DELAWARE ENGINEERING, D.P.C.

Re: Village/Town of Mount Kisco – Saw
Mill Pump Station Upgrades Project –
Contract #2022-02

Addendum # 2

A-107

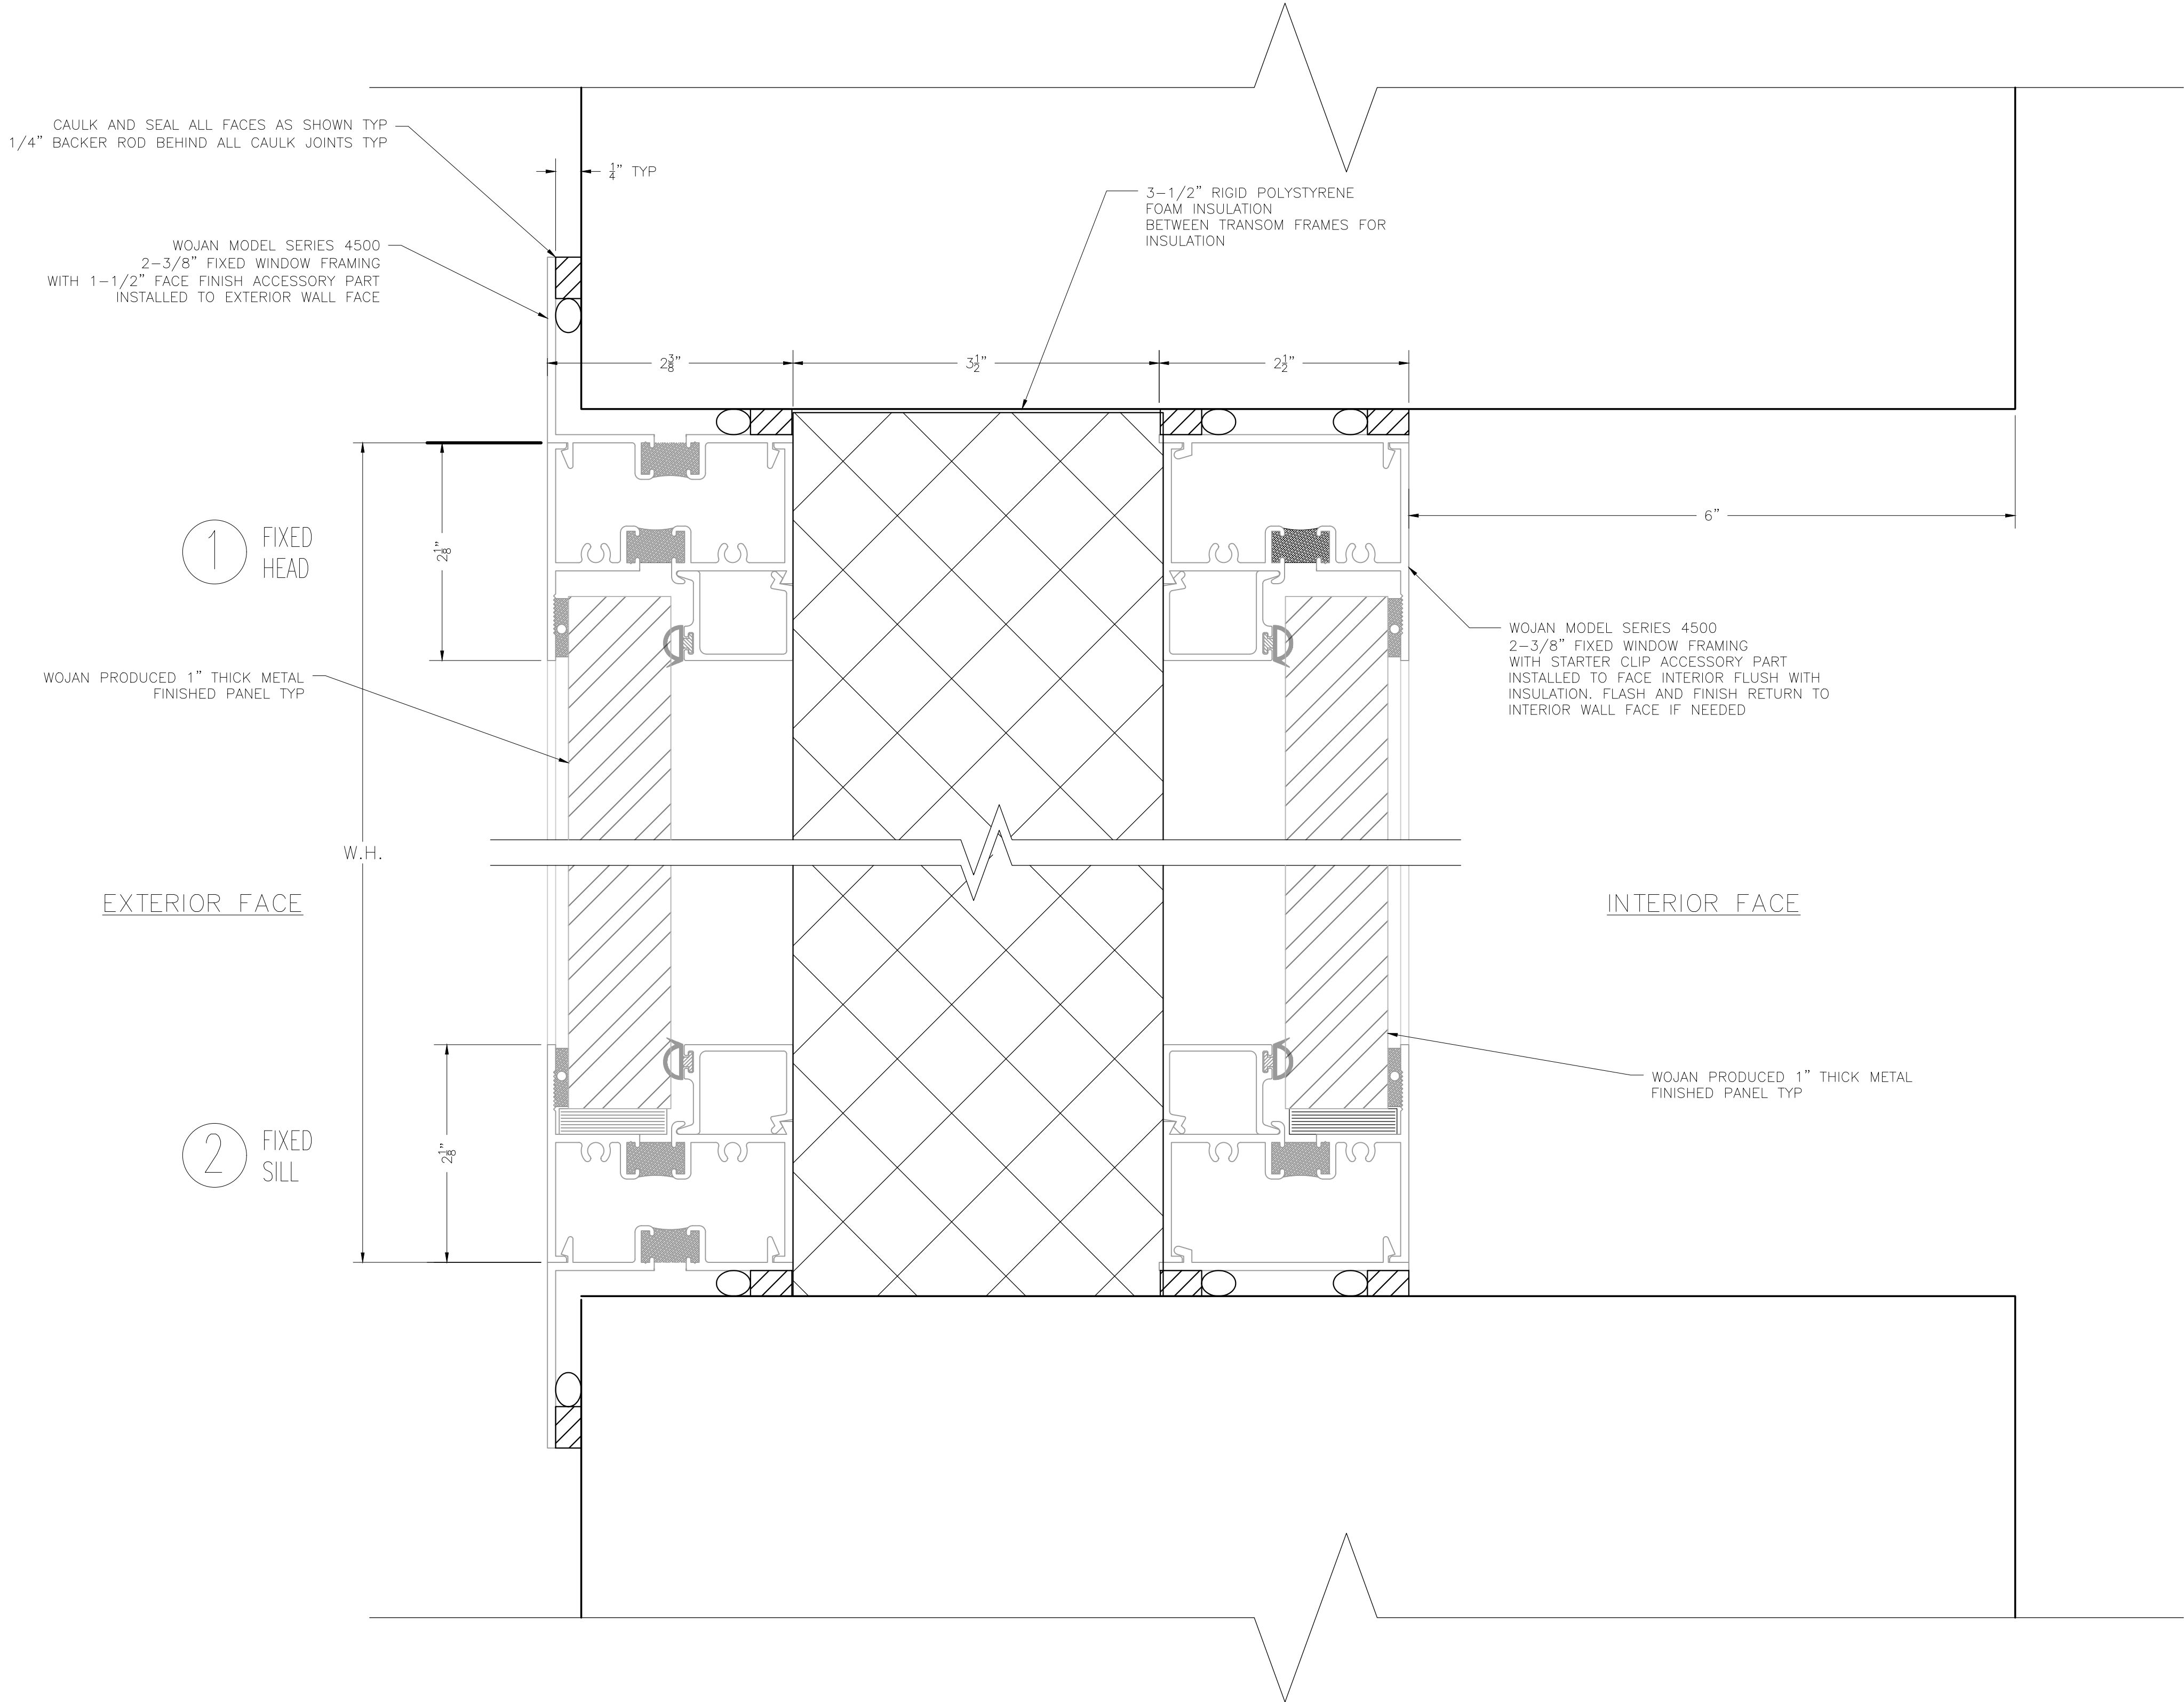
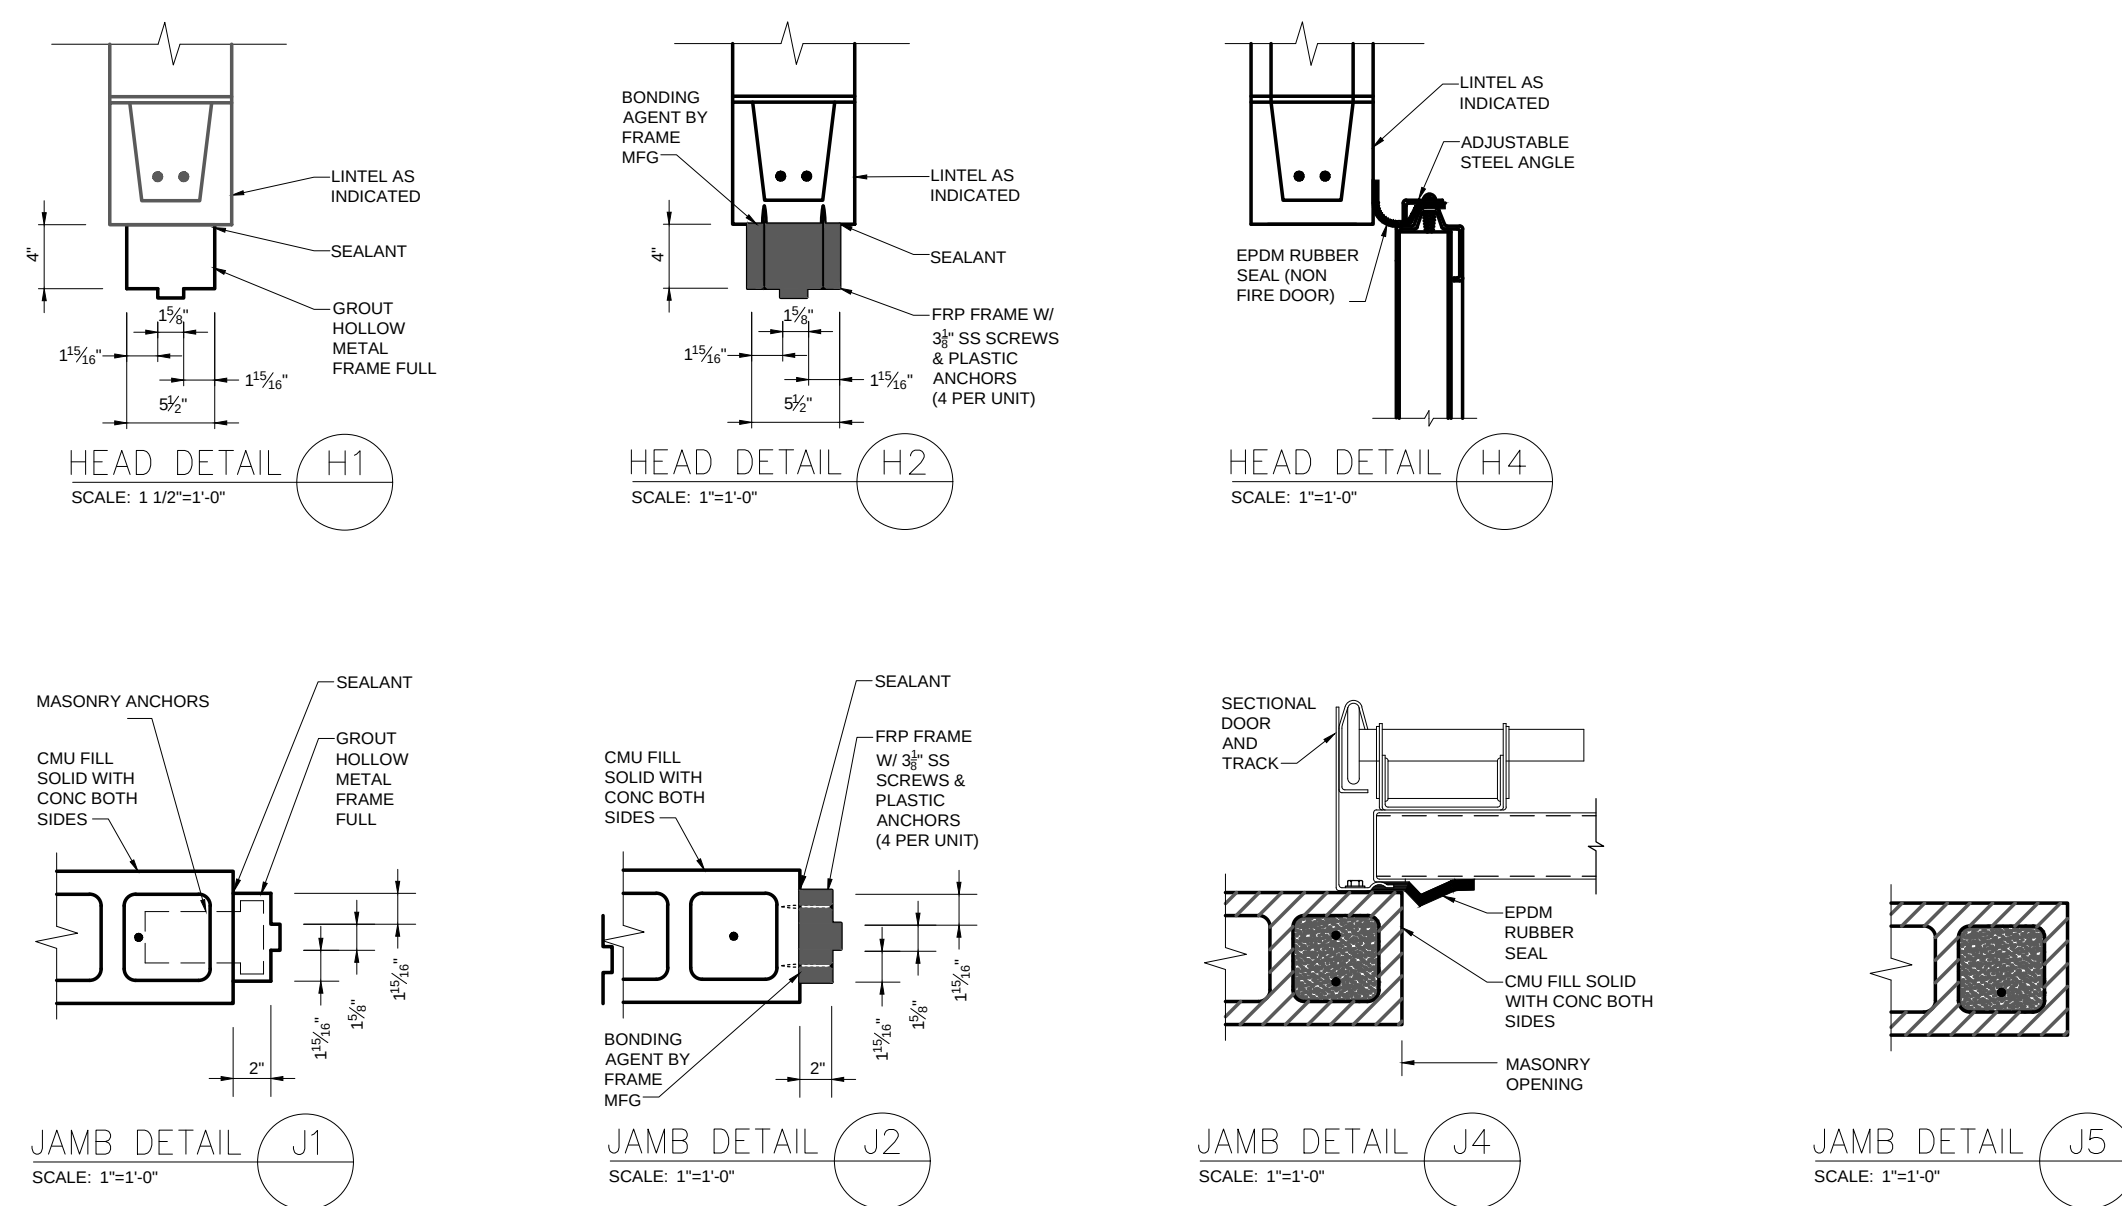
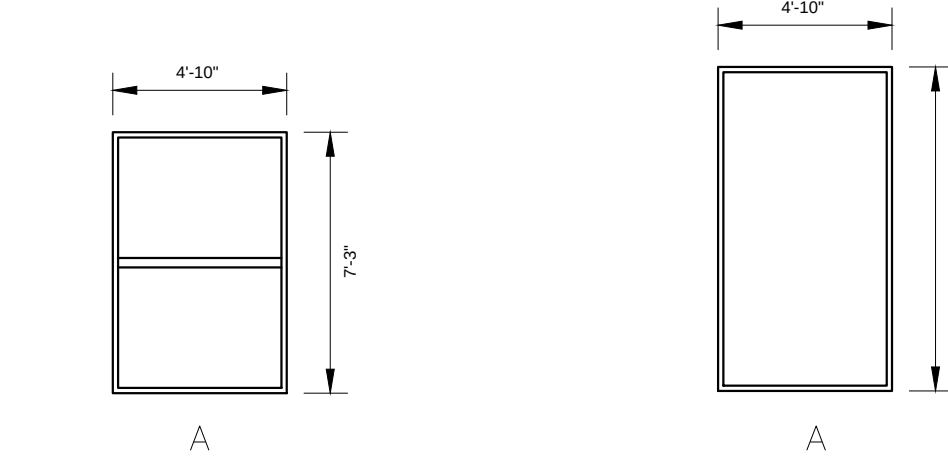
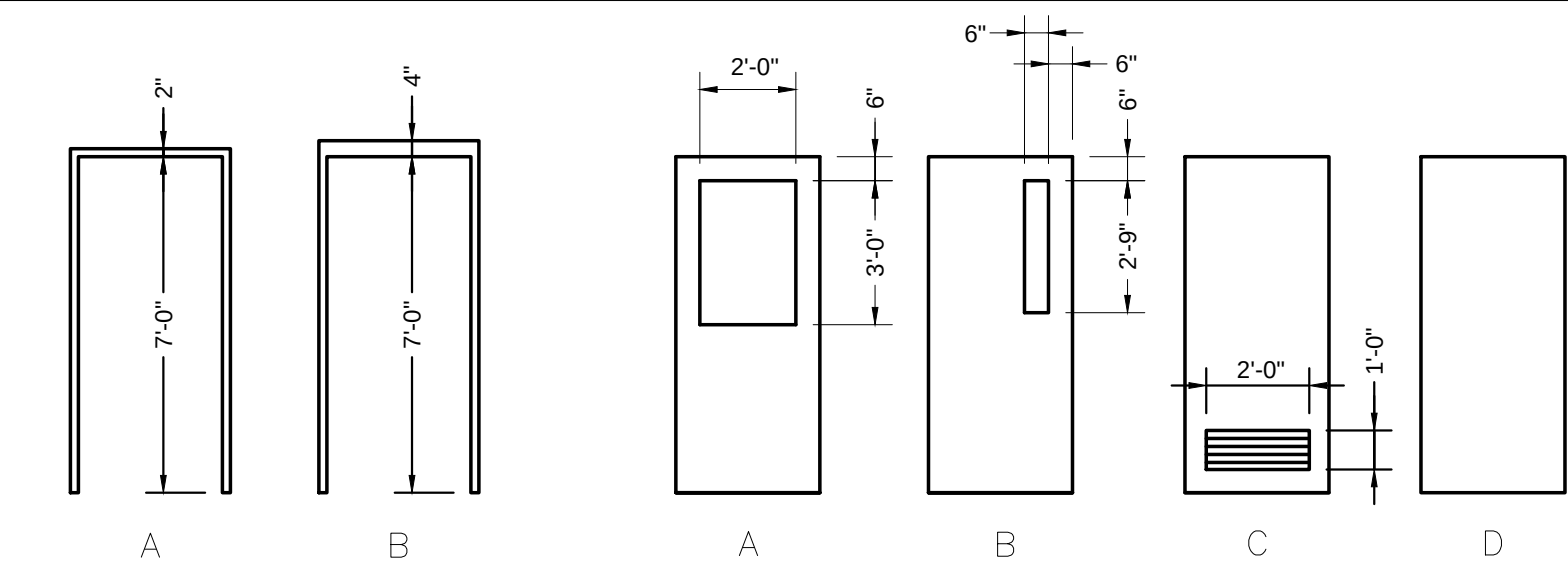
- The four interior doors not included in the door schedule on A-107 are the same as D6 on the door schedule.
